INITIAL FIRE SAFETY INSPECTION REPORT

Knittex Industries Limited (Extension)

RSC ID: 25932

Date: 01-Jan-2025

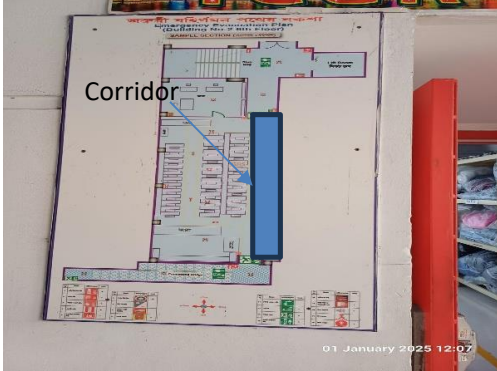
F-02	Fire Rated Construction	Storages were found underneath the cutting tables. Location: 3rd and 4th floors of Building-03.	Storage underneath the cutting tables shall be kept clear of combustibles at all time, except as provided for miscellaneous storage in accordance with 3.4.2.1.6 or where automatic sprinkler protection is installed. Where an automatic sprinkler system is installed sprinklers are required to be installed beneath cutting tables greater than 4 ft in width that are used for storage of combustibles.	Within 3 months
------	-------------------------	---	--	-----------------

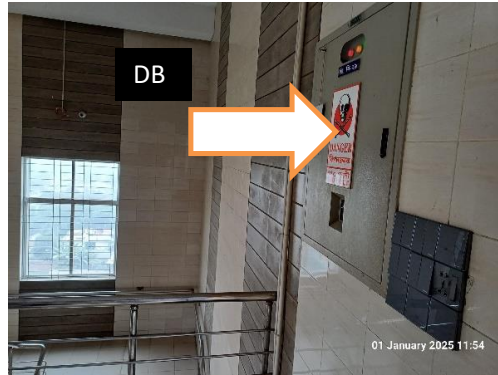
F-12	Means of Egress	Electrical panels were located in the exit stair enclosure. Location: Top floor building - 03.	Remove and re-locate all electrical panels from exit stair enclosures to a safe location.	Within 3 months
------	-----------------	--	---	-----------------

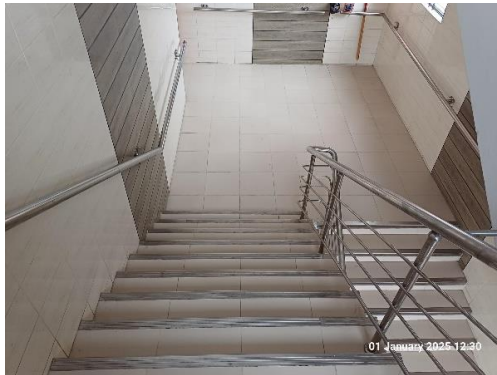
F-16	Means of Egress	Stair clear width was found less than 60 in. Location: Back-Stair at Building - 03. (available stair clear width is 44 in.)	Stairs shall have a minimum clear width of 60 in. for all industrial occupancies.	Within 3 months
------	-----------------	--	---	-----------------
